Reviewed No Exceptions Noted ()
Reviewed Exceptions Noted (X)
Revise and Resubmit ()
Rejected ()

PROJECT TITLE:
WALLER CREEK
ITEM NUMBER:
GR-IF-120.1R
DESCRIPTION:
BENCH
SPECIFICATIONS:
MATERIAL: ST-01: PORTUGAL BEIGE LIMESTONE UP-120.1R: UPHOLSTERY
FINISH: STONE: HONED SURFACE CHISELLED SURFACE ALL SURFACES: MATTE PROTECTIVE SEALANT
NOTES:
JOB NO: 320C
DRAWN BY: MK/YA
DATE DRAWN: 6/25/2025
SCALE: AS NOTED
SHEET:

GR - IF - 120.7
石头：葡萄牙米黄
加工：哑光面+自然边+防水
数量：1套

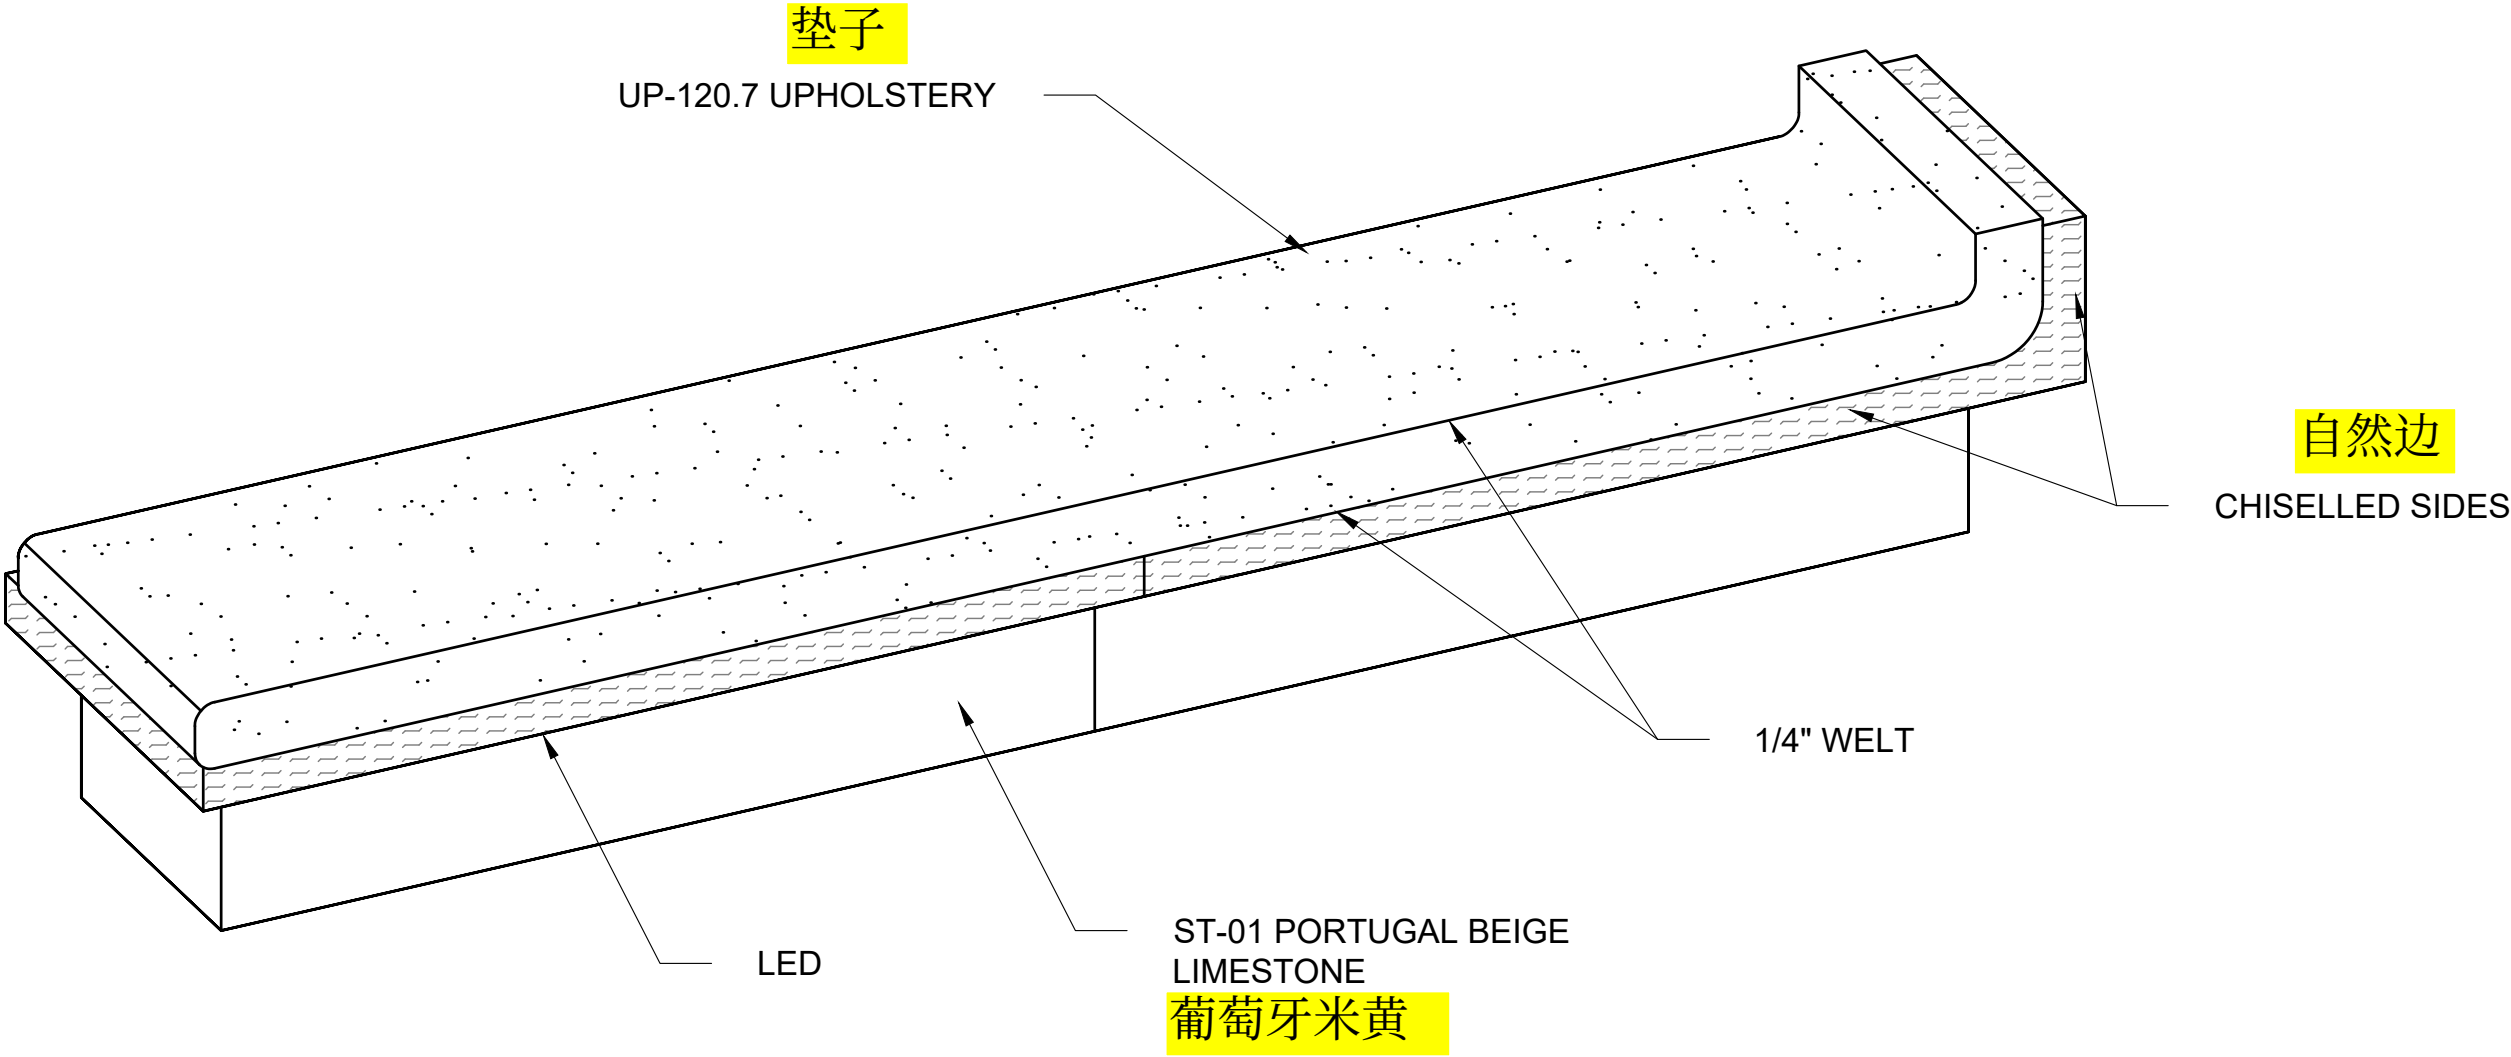
GENERAL NOTE
STUDY HEIGHT OF BENCH WITH TABLE AND CHAIR

Reviewed No Exceptions Noted ()
Reviewed Exceptions Noted (X)
Revise and Resubmit ()
Rejected ()

GD - IF - 120R
石头：葡萄牙米黄
加工：哑光面+自然边+防水
数量：10套

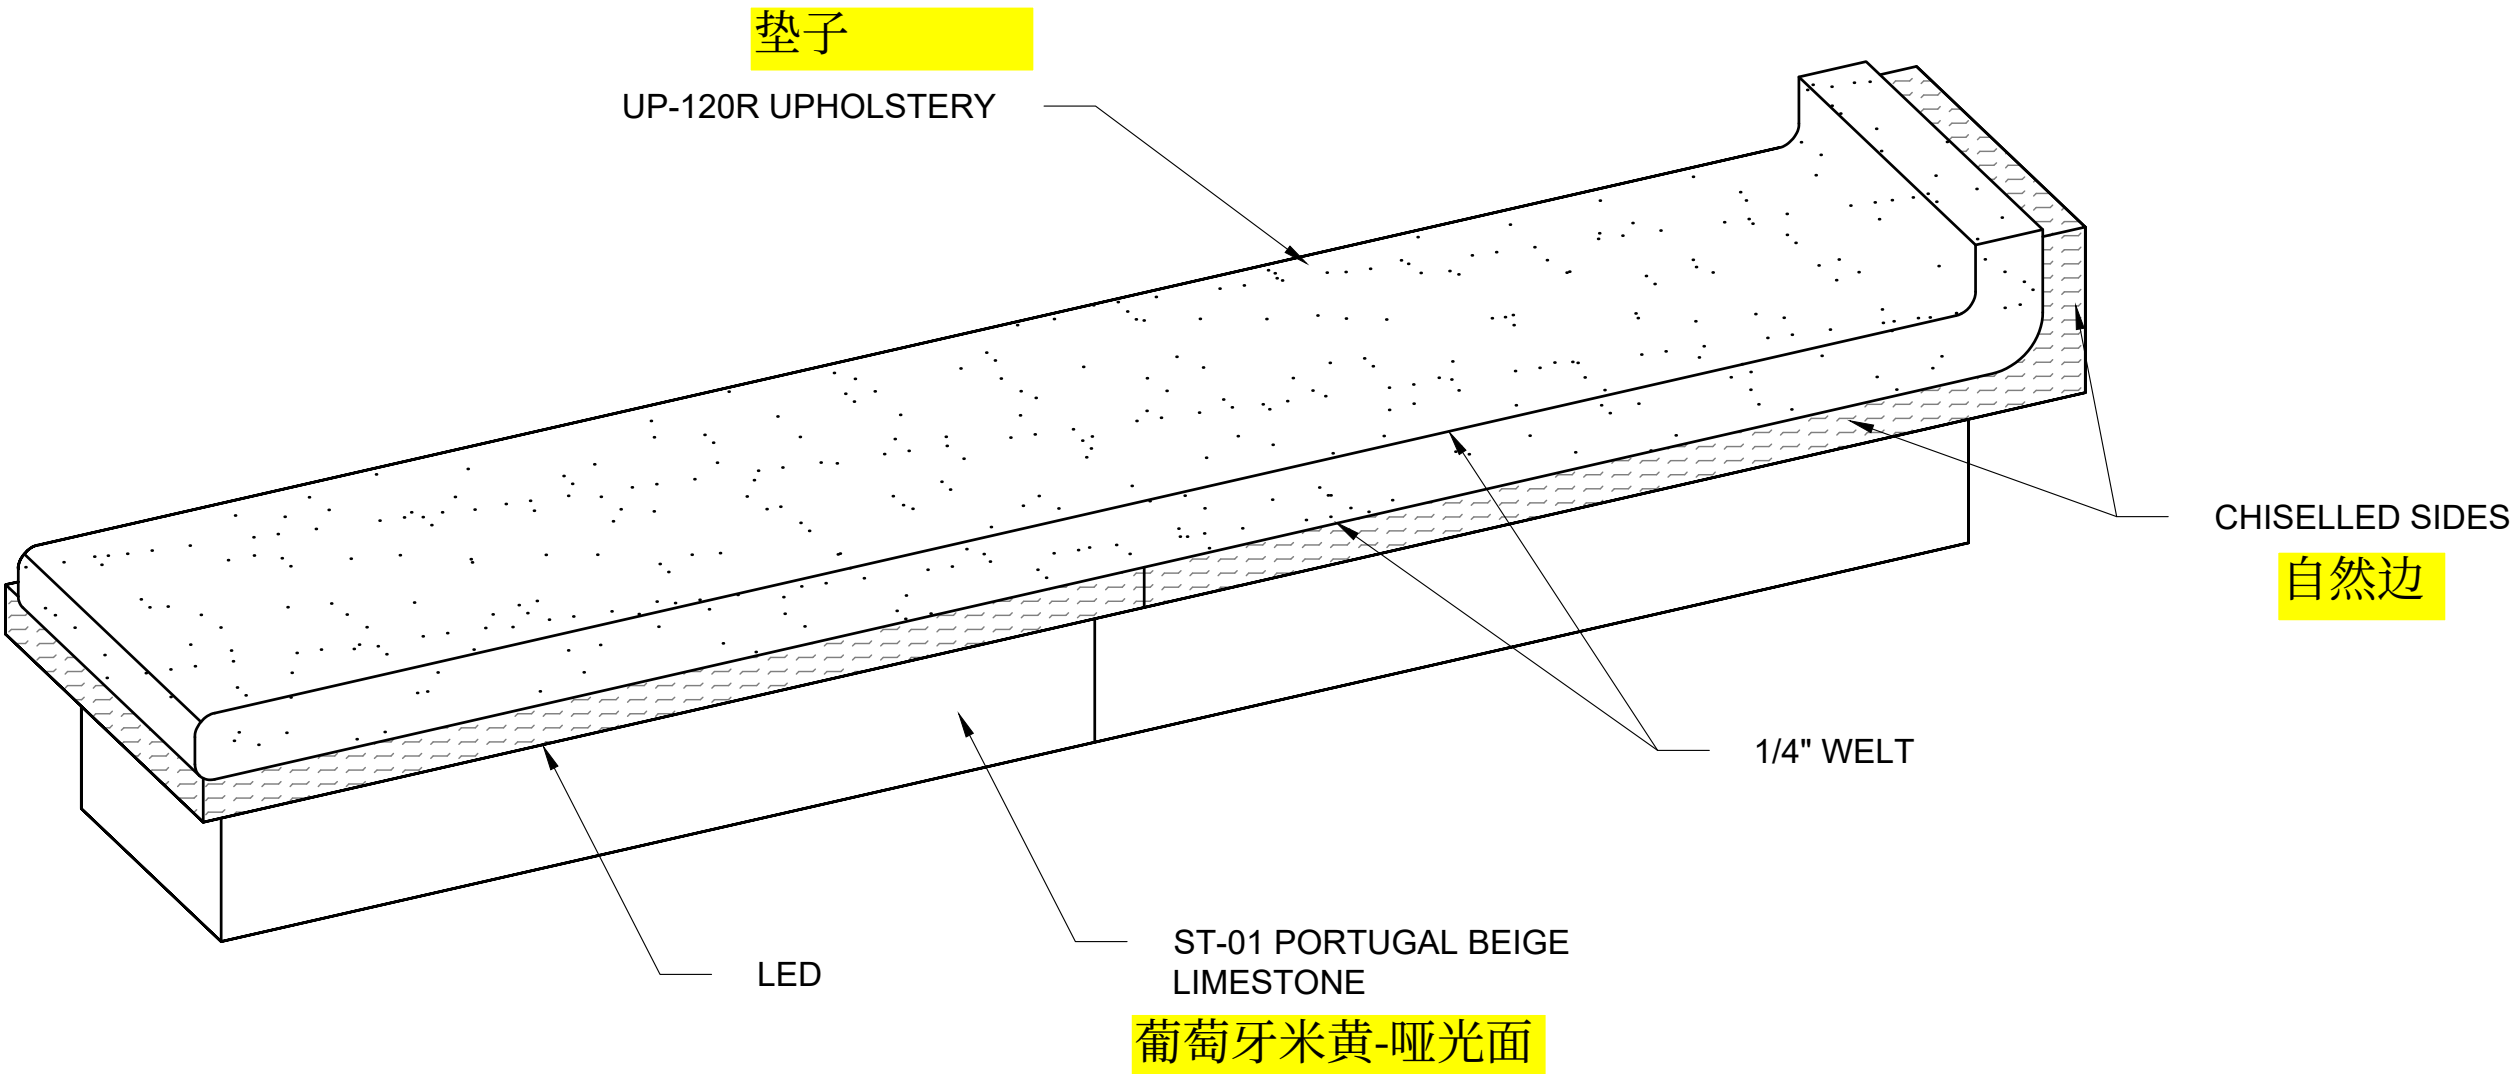
GENERAL NOTE
STUDY HEIGHT OF BENCH WITH TABLE AND CHAIR

Reviewed No Exceptions Noted ()
Reviewed Exceptions Noted (X)
Revise and Resubmit ()
Rejected ()

GR - IF - 120L
石头：葡萄牙米黄
加工：哑光面+自然边
数量：32套

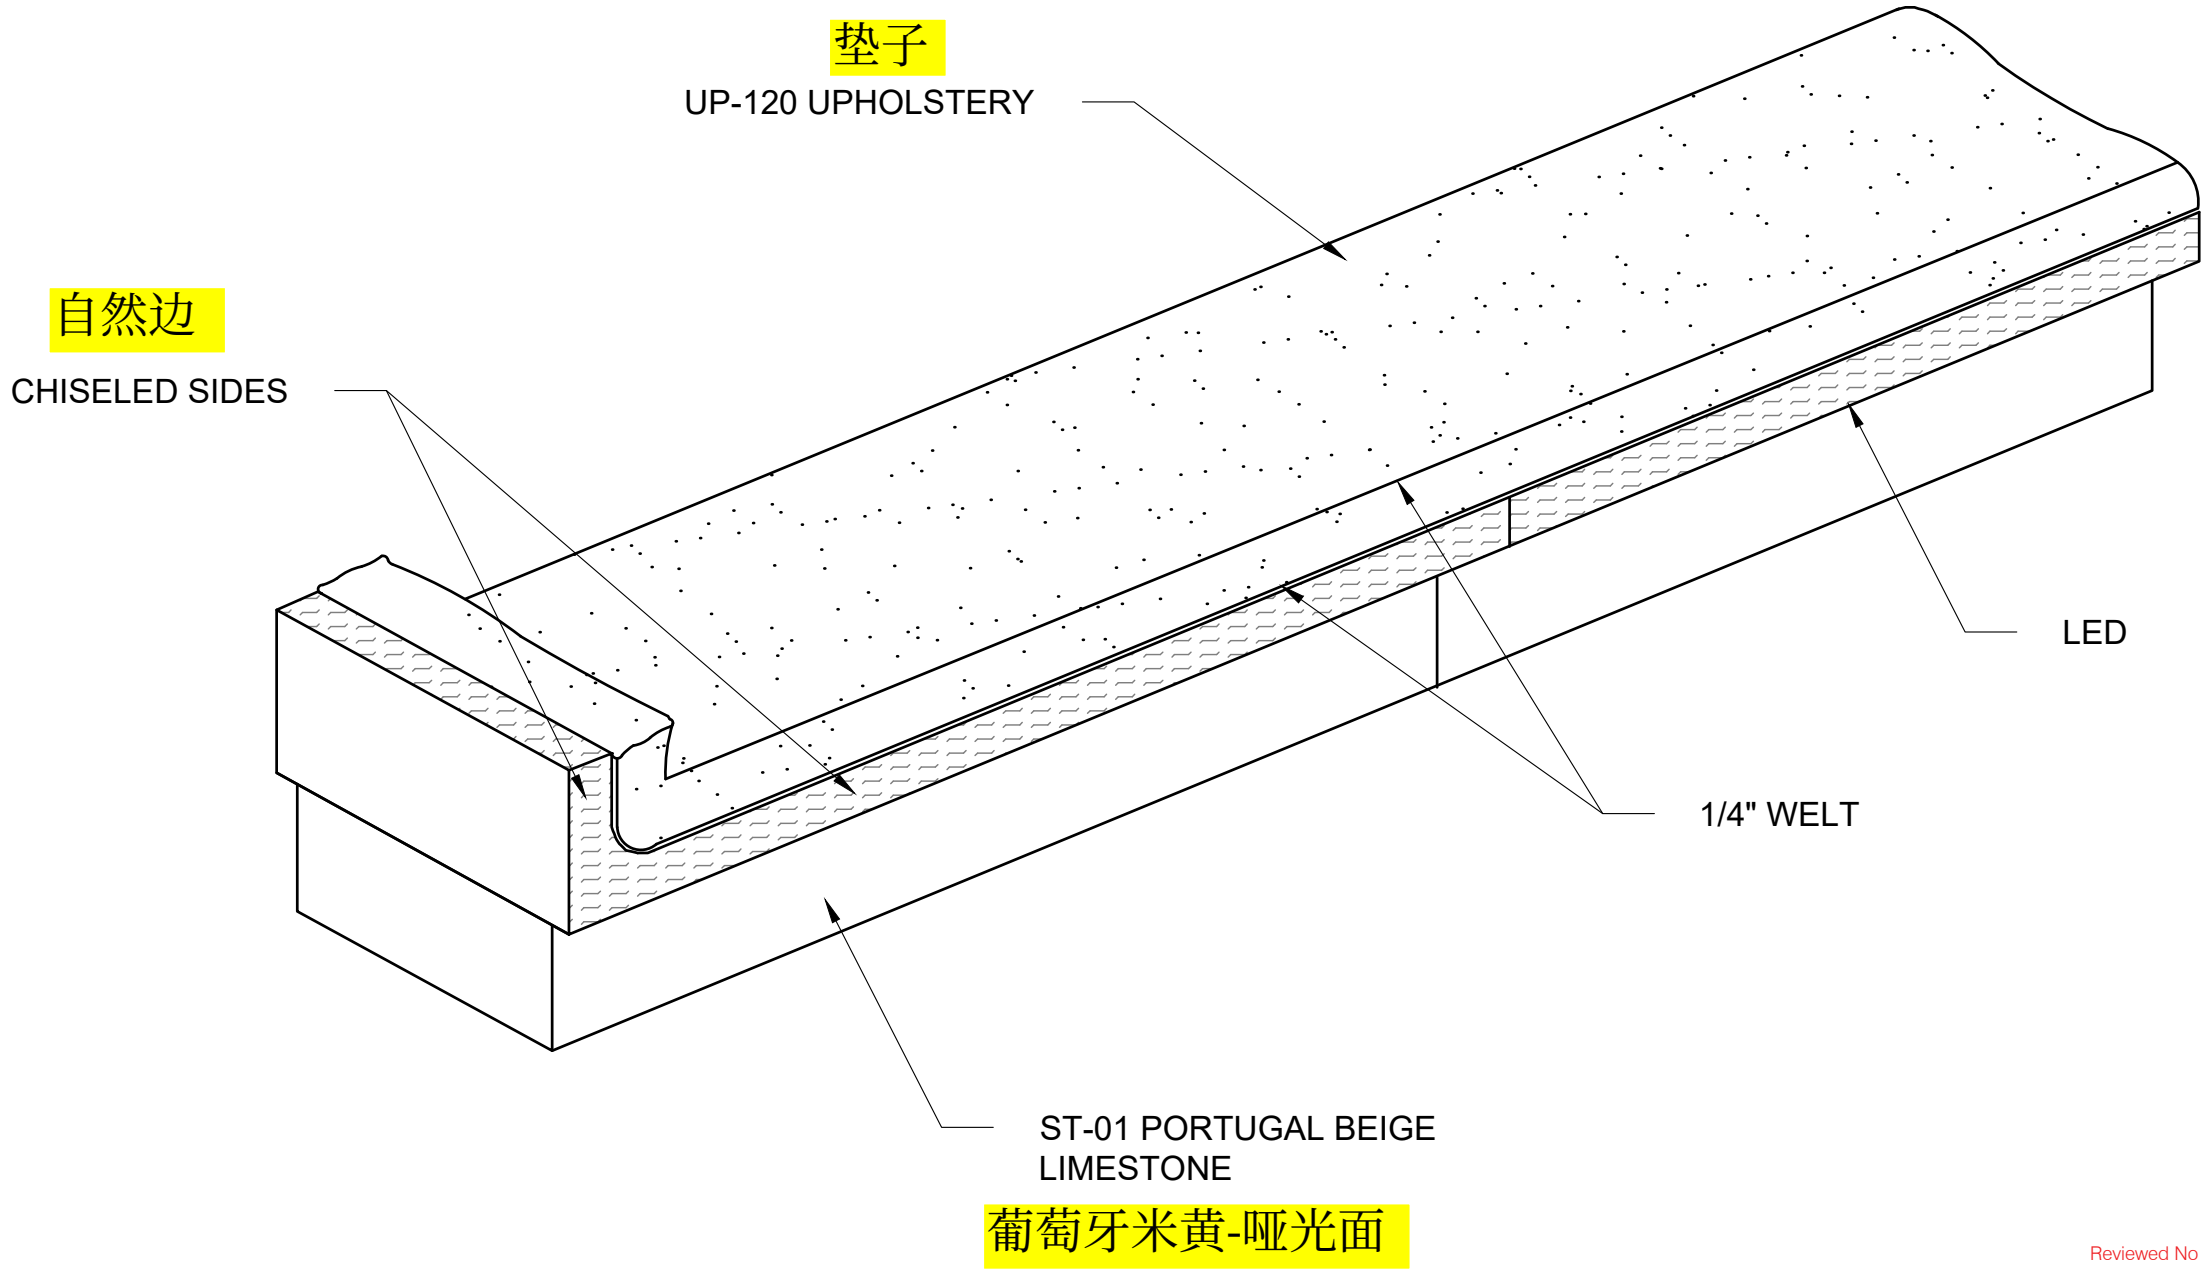
GENERAL NOTE
STUDY HEIGHT OF BENCH WITH TABLE AND CHAIR

Reviewed No Exceptions Noted ()
Reviewed Exceptions Noted (X)
Revise and Resubmit ()
Rejected ()
